#### 6.1.2 Amendment C274 – Officer South Employment PSP/IPC

That Council having considered Planning Scheme Amendment C274 (Officer South Employment Precinct Structure Plan and Supplementary Infrastructure Contributions Plan), Council endorses the enclosed submission in Attachments 1-4 to be submitted to Victoria Planning Authority for consideration.

**Figure 1. Active Sport Reserve Land Requirements**

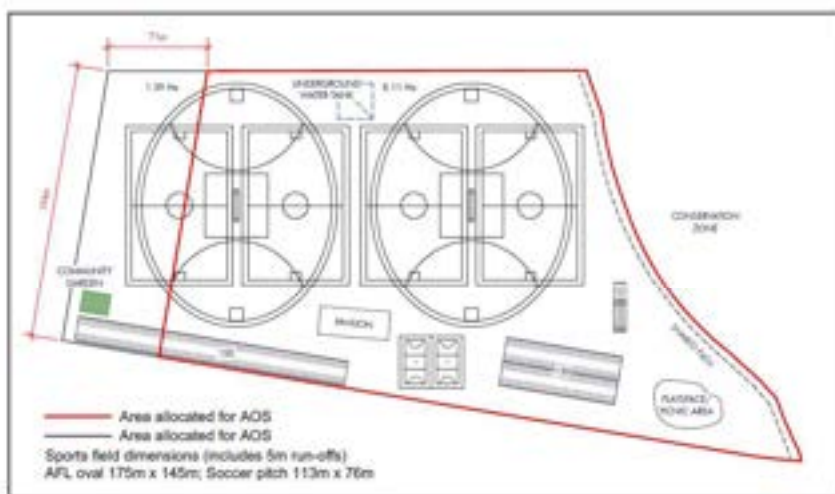
The shape of the land allocated to the Sports Reserve SR-01 is important and needs to be of an appropriate shape to achieving an optimal design, layout and functionality for the reserve. The present shape of the land is not conducive to accommodating the required field-based sport activities as shown in Figure 1 in bold red. The shape of the reserve along the eastern boundary is tapered in the southeast corner, which creates a narrow wedge that is unable to contribute to the land area required for any of the field-based sport activities. The most efficient land shape for a sports reserve accommodating ovals and rectangular fields is a rectangle shape. The functionality of the Local Sports Reserve SR-01 is compromised by its current shape, which greatly influences land size.

To achieve the optimum and most sustainable layout, an additional 1.39 ha is required to the west to offset the impact of the inefficient shape of the land that is currently allocated to Sport Reserve SR-01. Council respectfully requests Sport Reserve SR-01 is modified and the shape of the land is extended along the western boundary by an estimated 71 metres to create a 9.5-hectare parcel of land, as shown in Figure 1 to accommodate the required sporting facilities and supporting infrastructure. This alternative increases the total area of the Sports Reserve SR-01 from 8.11ha to 9.5 hectares, to comply with Cardinia's Active Cardinia Strategy 2023 and Recreation Reserve Facility Standards Policy 2019 (or as amended).

**Figure 3. DSS Asset Overview**

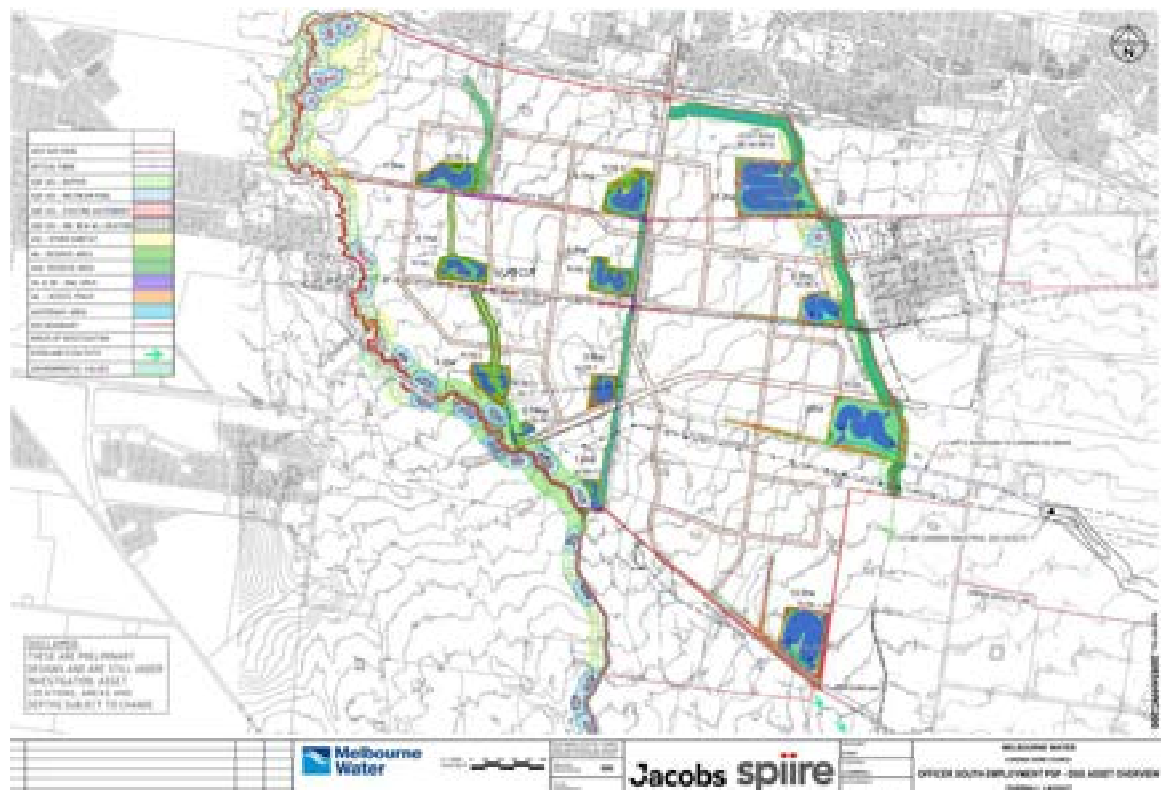
Council observes a parcel of land located to the east of Officer South Road, circled red in Figure 3 is landlocked, based on the alignment of the proposed drainage waterway. Council requests for Melbourne Water and the Victorian Planning Authority to investigate and confirm access to this site can be achieved, prior to the finalisation of the Amendment.

Figure 1 – Plan 9, Integrated Water Management, Officer South Employment Precinct Structure Plan, marked to show IWM trial proposal locations

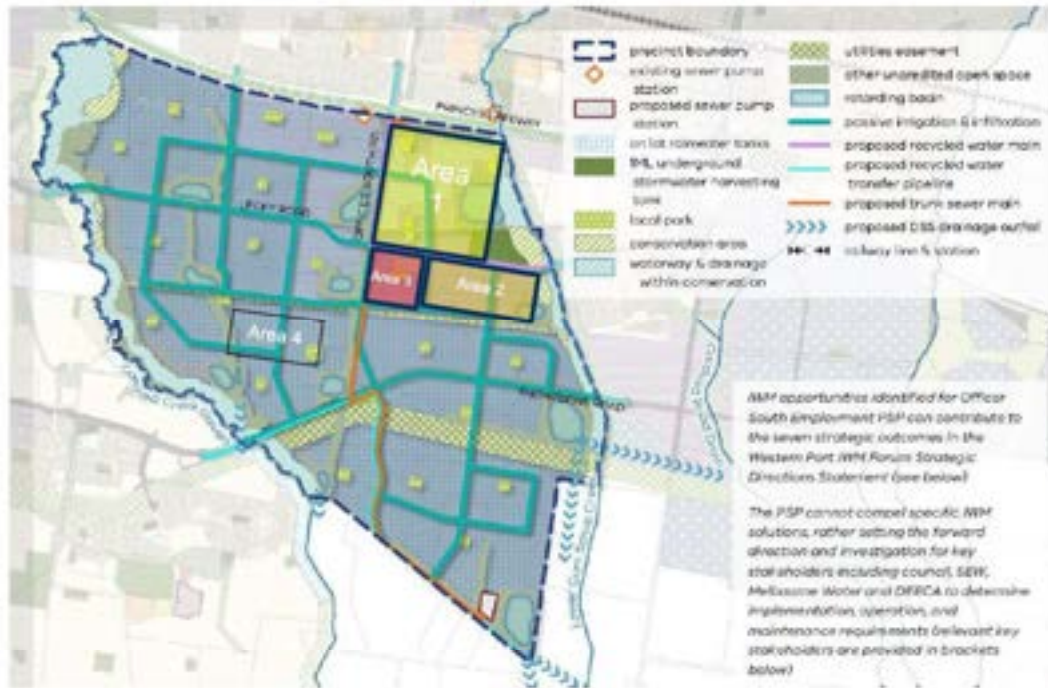
Council notes on Plan 9 (Integrated Water Management) of the Draft PSP a 1ML stormwater harvesting system (water tank) for the sports reserve is proposed. Council is concerned the sport reserve is an inefficient shape and does not currently have enough land to accommodate the proposed sport reserves, facilities and proposed stormwater harvesting (water tank) system due to the limited size of the sport reserve. Council requests for more land is allocated to Sport Reserve SR-01 to accommodate the future tanks.

**Figure 7. Plan 10 Modifications to be considered.**

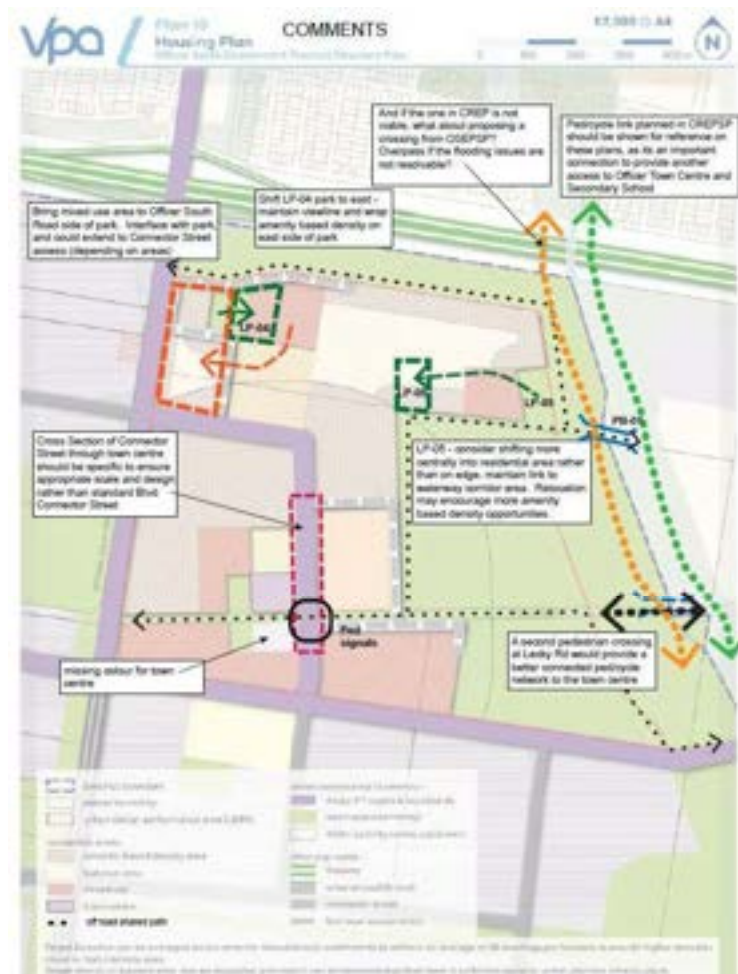
Council requests adjustments are made to Figure 6 (Housing Plan 10) regarding the arrangement of land uses on the Place Based Plan (Plan 3) and the Housing Plan (Plan 10), which in turn impacts other items in the PSP documentation.

5. Noting density area/buffers are shown, could the slither of balance area within the northwest corner be removed, as this will create implementation issues in accurately calculating densities (especially if the required is strictly minimum). Please note this issue may be resolved if Councils recommendation to shift the local park is adopted.
6. The relocation of the town centre. At present the town centre is split between two landowners. It would be preferred to locate the town centre on one landholding to assist its future development.

**Local Access Street Level 2 – Industrial (22m)** **VPA Standard Cross Section**

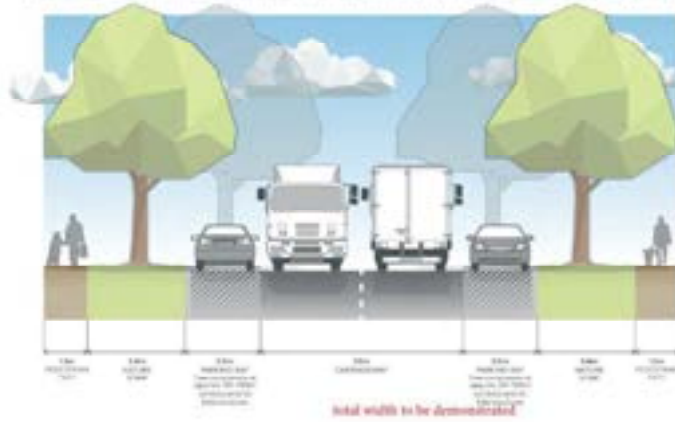
1. The location of indicative lighting poles demonstrate on cross-section
2. This cross-section is not demonstrated on Plan 4 (Road network 1). The POP needs to demonstrate Level 1 and Level 2 cross-sections

**Revised note – the road reserve width may need to increase to include the retention of very high and high value trees and accommodate 30% tree canopy in accordance with Australian Standard AS 4970:2009.**

Figure 15: IN-01 intersection layout required to accommodate the anticipated volumes (RTA Guide)

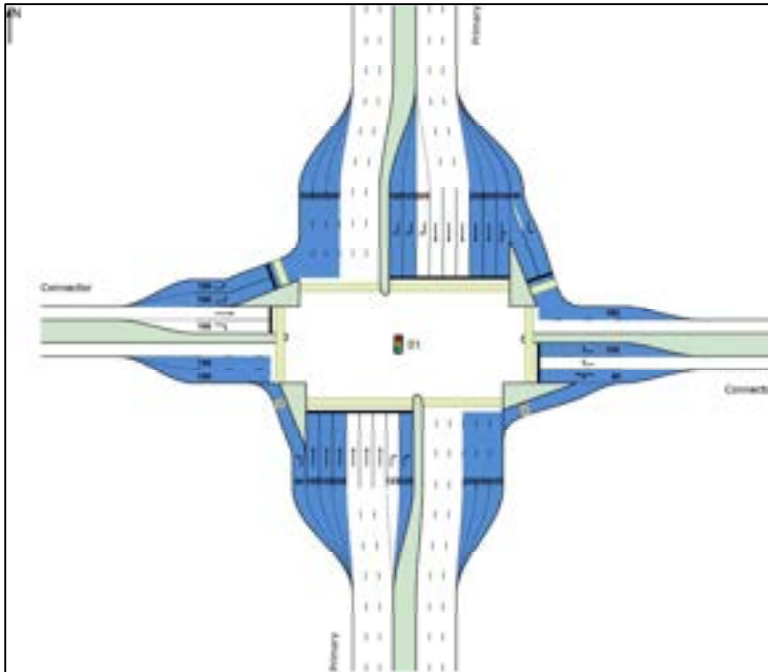
As a result, the VPA standard benchmark layout was used as a base, with modifications made to the intersection layout as required (including adding / lengthening lanes and adding slip lanes) to cater for the traffic volumes and to achieve the target DOS of 0.9 for signalised intersections.

The intersection required to accommodate the anticipated traffic volumes (RTA Guide) is shown in Figure 15. Any additional lanes required when compared with the VPA standard benchmark intersection are highlighted in blue. A summary of the SIDRA outputs is shown in Table 10.

Figure 16: IN-01 intersection layout, as per Ratio ITA and the VicRoads design layout

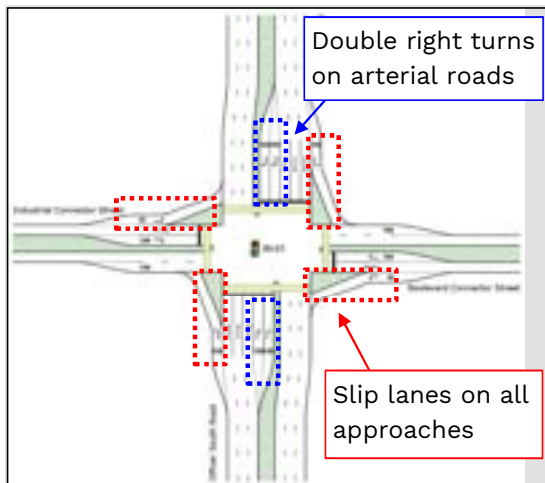
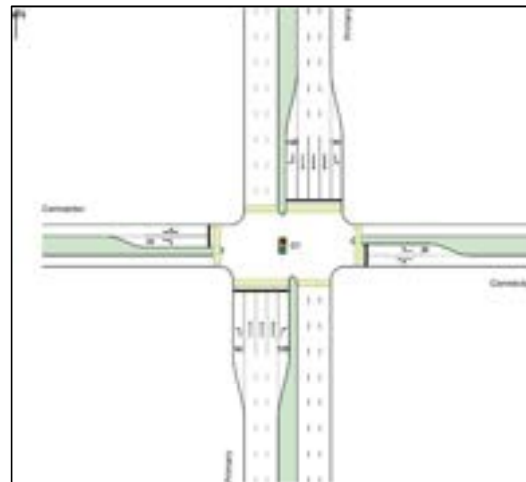
- This intersection includes additional right turn lanes on the primary arterial road and slip lanes on all legs, which are not provided in the VPA standard benchmark design (refer to Figure 16 and Figure 17).

- The ICP does not allow for an additional / supplementary levy for IN-01 above and beyond what is provided for the VPA standard benchmark intersection. Noting the additional lanes provided, the intersection could not be delivered within the standard footprint (requiring additional land take) or adequately funded by the standard ICP levy applied.
- As analysis has not been provided, it is unclear if this alternative intersection layout would also be applicable to the other Primary Arterial Road / Connector Road intersections within the PSP (i.e. IN-08, IN-09, IN-11 and IN-12).

Figure 19: Arterial road spacing

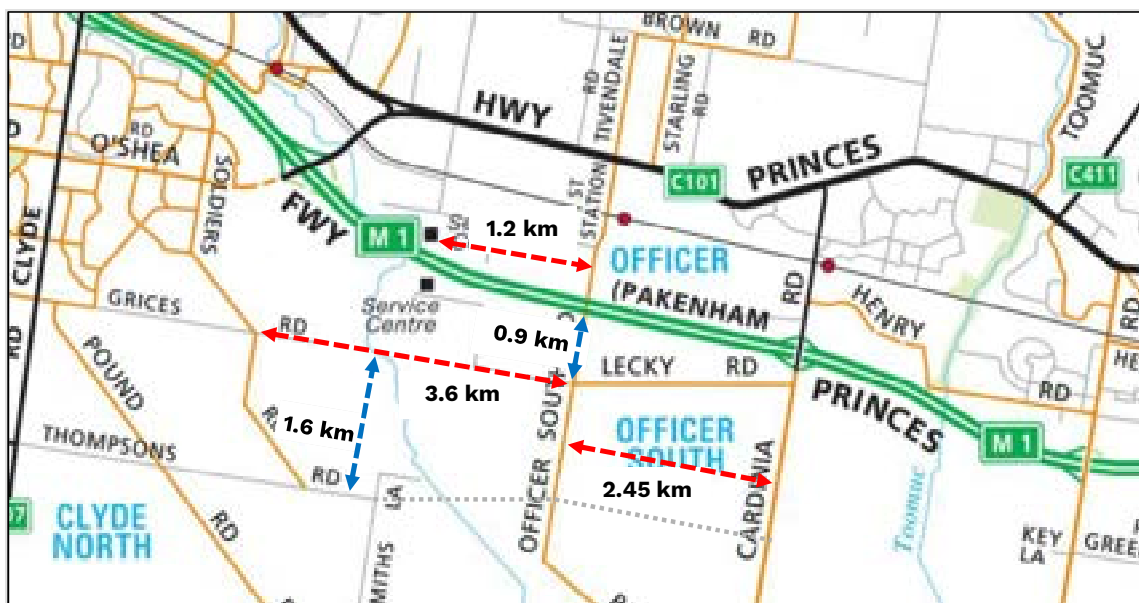
While the east-west connections generally meet the access management and one mile grid principles, there is a lack of north-south connections within the PSP network resulting in capacity constraints and congestion for the north-south movement.

Ideally, a new additional north-south arterial road connection should be provided within the PSP area to disperse traffic. The only location that may be suitable would be upgrading the Stephens Road bridge (and the north-south connector road south of Stephens Road) to provide an additional major north-south connection to the Princes Freeway and out of the PSP area. This connection would provide much needed additional road capacity.

Figure 24: Local Access Street – industrial

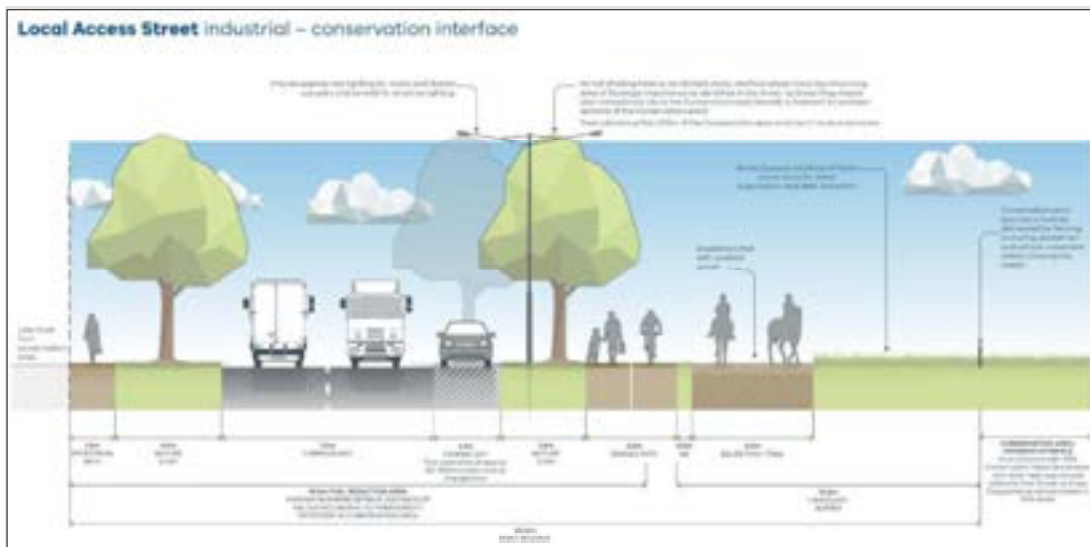
It is noted that the provision of the equestrian trail is also included in the Local Access Street (industrial) cross section presented in the PSP, indicating a 4.0 m wide crushed gravel equestrian trail (refer to Figure 24).

However, there is no further information provided in the PSP to inform the design or delivery of the proposed equestrian trails to ensure safe and suitable road crossing points are provided along the trail. This is of particular concern at the arterial road crossings at Thompsons Road (6 lane primary arterial) and Lecky Road (4 lane secondary arterial), where standard pedestrian crosswalks are unlikely to cater for the specific needs of horses.

It is recommended that the PSP provide further guidance on how safe road crossings for horses along these equestrian trails can be provided.
